Subject: Official Community Plan (OCP) and Zoning Bylaw Amendment – École de la Vallée

Craig Burns, Agent on behalf of the landowner 1193317 BC Ltd. (Bruce van Mook) has made an application from Conseil scolaire francophone de la C.B. (School District #93) to the Village of Pemberton for amendments to the Village's Official Community Plan (OCP) and Zoning Bylaw to facilitate the development of a Francophone public school - École de la Vallée. The subject property is known as the portion of the Tiyata development that fronts Highway 99. The subject lands are depicted in **Appendix A**.

Your File #: OR131 – École de la Vallée (CSF)
MoTI File #: 2020-05459
Date: Nov/09/2020

Re: OR#131 – École de la Vallée OCP and Zoning Bylaw Amendment

Figure 3 – Highway Access Concept Plan

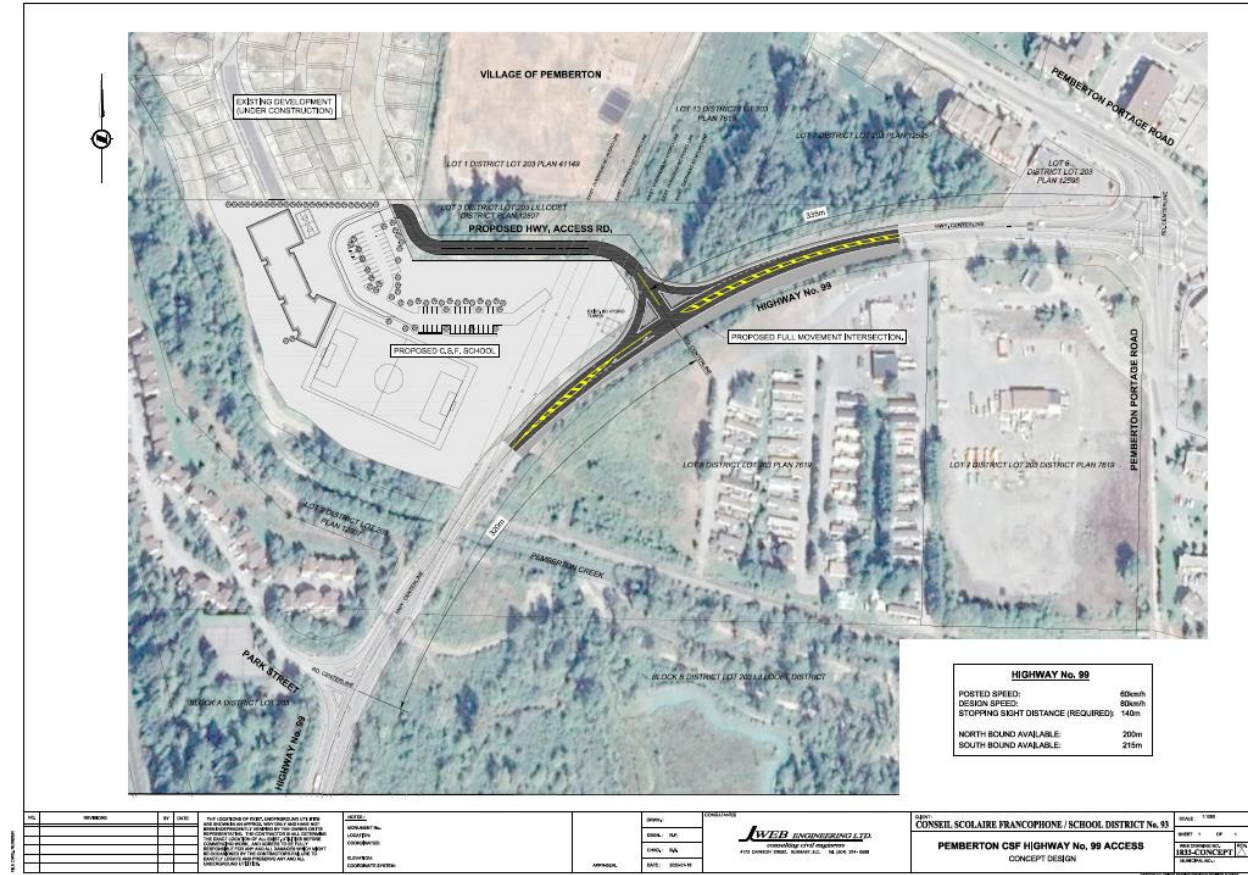
In review of the referral package and the proposed Highway access road layout designed by WEB Engineering, concerns about fire department access for both Tiyata and the French School are noted.

The original submission drawing showed a turnaround in Tiyata and the WEB Engineering drawing no longer shows this. As per Building Code requirements stated below road allowances are required. Also as per the Approved Fire Apparatus turn around (**Appendix F**) by the International Fire Code, access and turn arounds need to be met.

Need confirmation whether the [gated] access from Tiyata through to the French School will be included as the WEB Engineering drawing does not indicate this clearly. The French school parking does not seem to be a drive through as indicated in the first drawing, and the building seems to be further away from the road or driveway where there are requirements for this as well.

Hydrant locations will also have to be looked at closely.

Once this is reviewed we can have a further discussion. This is one area that is a big problem in Pemberton, Fire Department access that definitely needs to be addressed.

Although the Ministry’s preference is to limit or eliminate private access off of Highway 99 through Pemberton, as it is a Controlled Access Highway, we recognize the challenges with this parcel in that it currently does not have frontage on a secondary road right of way and there is limited opportunities to establish alternative access. The applicant will need to address and consider the following

- *An Access to a Controlled Access Highway permit is required for direct access to Highway 99.*
- *Presently, the ministry supports a right in/right out access to Highway 99. This present support should not be construed as pre-approval for a full movement access. A full movement access will require further analysis and review.*
- *The proponent will need to consider the costs of potential improvements to the highway to support an access.*
- *Access approval may need to consider access to adjacent lands (e.g. through public road dedication or easements).*
- *Consideration should be made for active transportation and pedestrian accommodation.*

BC Hydro has begun its review of the referral and has asked for clarification as to where Transmission Tower 64-03 of Circuit 2L001 is located in relation to the proposed access road and the distance between the tower and the closest edge of the access road. The applicants are preparing a response to this request, which will include conducting a more detailed survey later in the process.
